ADDENDUM #3

June 7, 2010
Head of Falls Gateway Plaza
Waterville, Maine

RE: Addendum No. 3 to the Bidding Documents for:

HEAD OF FALLS GATEWAY PLAZA Waterville, Maine

GRANITE LOGO DETAIL

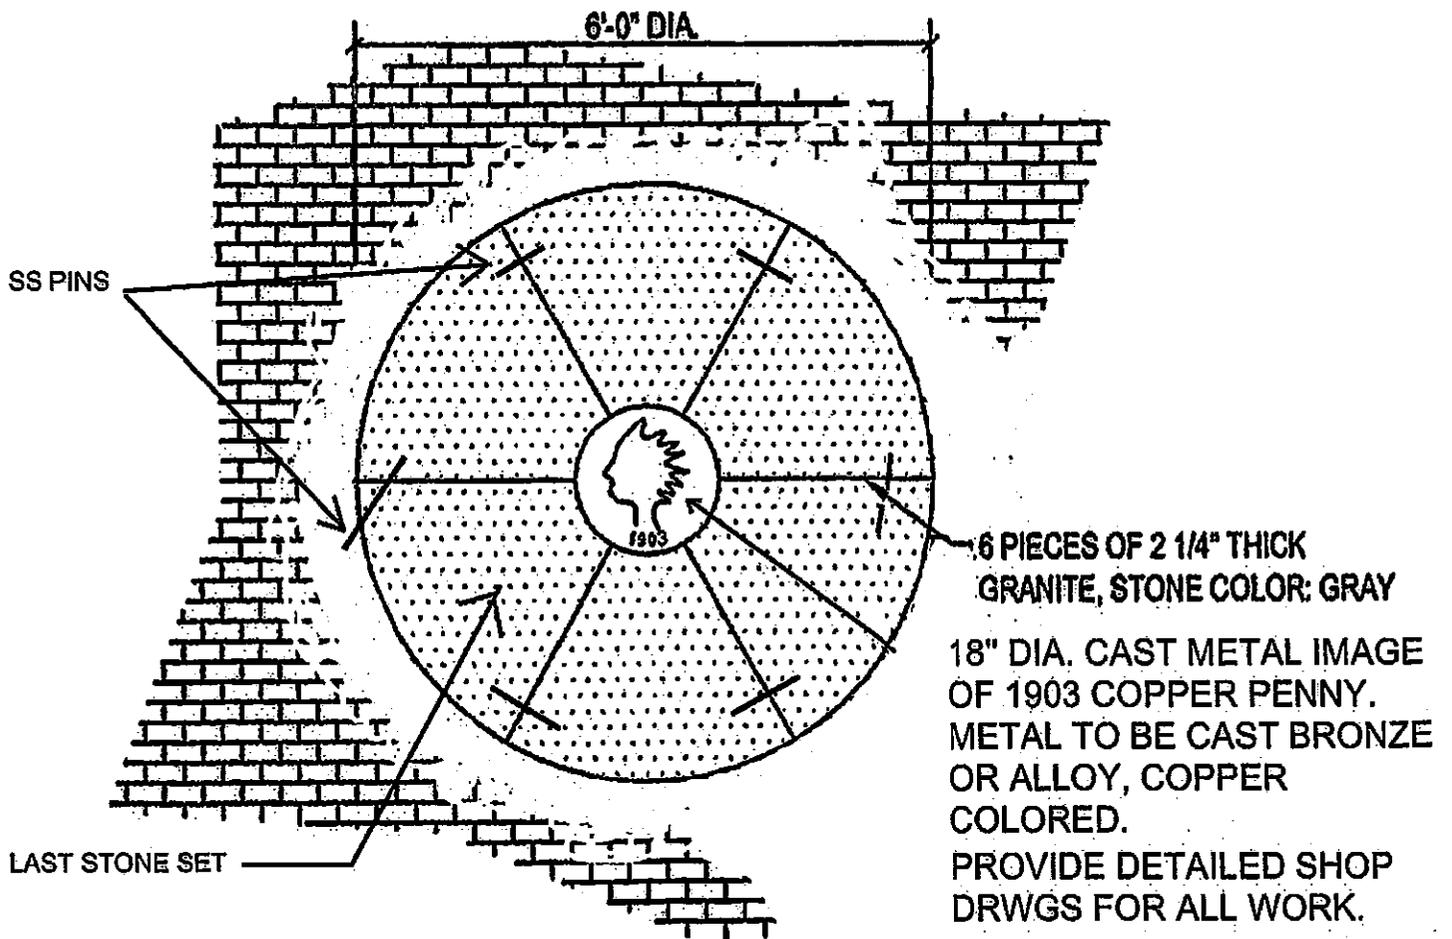
- 8. Where is detail 10 on the drawing L-104? This is referenced on L-105 detail 3.**

Enclosed attachment is detail 10.

GC TO SUPPLY 12 EA. 1/2" DIA. SS X 12" LONG PINS TO "LOCK" GRANITE WEDGES.
SUBMIT DRILLING DETAILS ON SHOP DRAWINGS. SUBMIT SHOPS TO OWNER.

THICKNESS/STRENGTH OF CAST METAL IMAGE SHALL BE SUFFICIENT TO SUPPORT
A 1000# POINT LOAD @ CENTER. [FULL BEARING AROUND PERIMETER].

SET METAL IMAGE IN A BED OF GROUT. SUPPLY SHOP DRAWINGS TO OWNER FOR
APPROVAL.
